Docket No. 50-423
B17276

Attachment 2

Millstone Nuclear Power Station, Unit No. 3
Proposed License Amendment Request
SLCRS Bypass Leakage
(PLAR 3-98-5)
Marked Up Pages

June 1998

TABLE 15.0-8

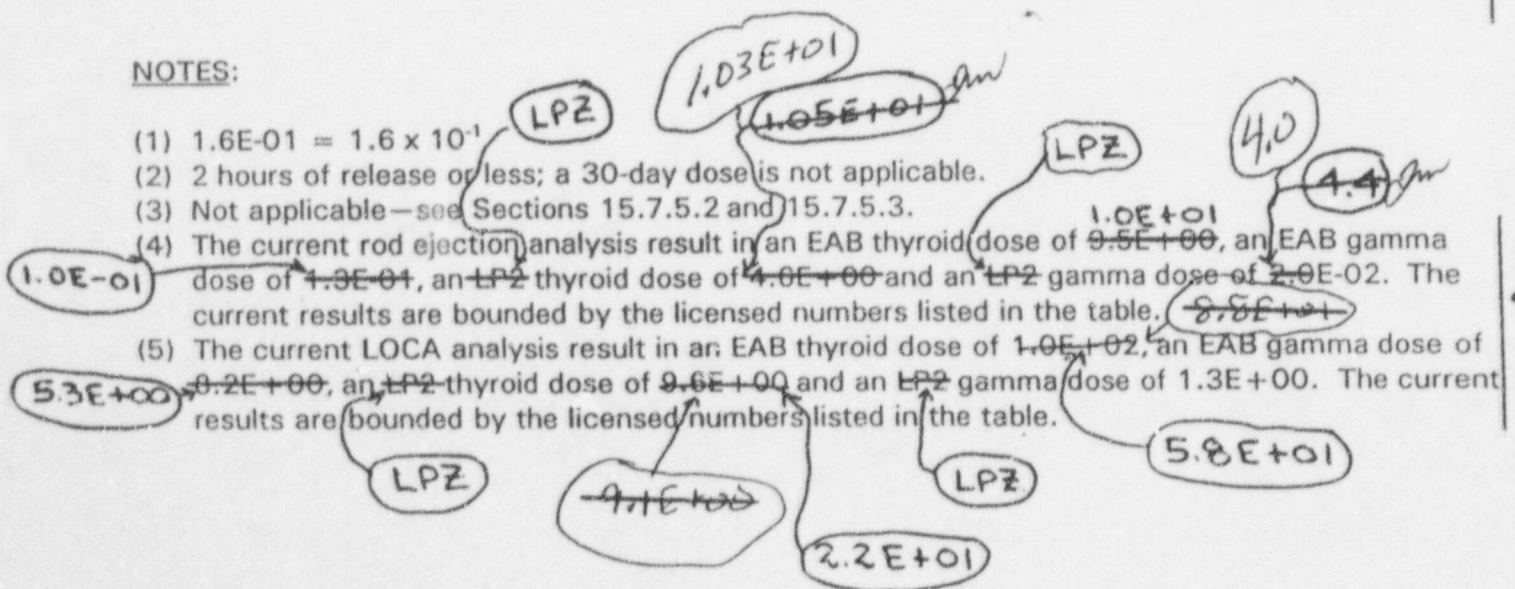
| Postulated Accident | FSAR Section | Dose (rem) 2 hr Exclusion Area Boundary (524 m) | | Dose (rem) Low Population Zone (3862 m) | |
|--|-----------------|---|------------------------|---|------------------------|
| LOCA | 15.6.5 | 1.4E+02 ⁽⁵⁾ | 9.4E+00 ⁽⁵⁾ | 3.0E+01 ⁽⁵⁾ | 1.7E+00 ⁽⁵⁾ |

(4) The current rod ejection analysis result in an EAB thyroid dose of $9.5E+00$, an EAB gamma dose of $4.3E-01$, an LPZ thyroid dose of $4.0E+00$ and an LPZ gamma dose of $2.0E-02$. The current results are bounded by the licensed numbers listed in the table.(5) The current LOCA analysis result in an EAB thyroid dose of $1.0E+02$, an EAB gamma dose of $9.4E+00$, an LPZ thyroid dose of $9.6E+00$ and an LPZ gamma dose of $1.3E+00$. The current results are bounded by the licensed numbers listed in the table.
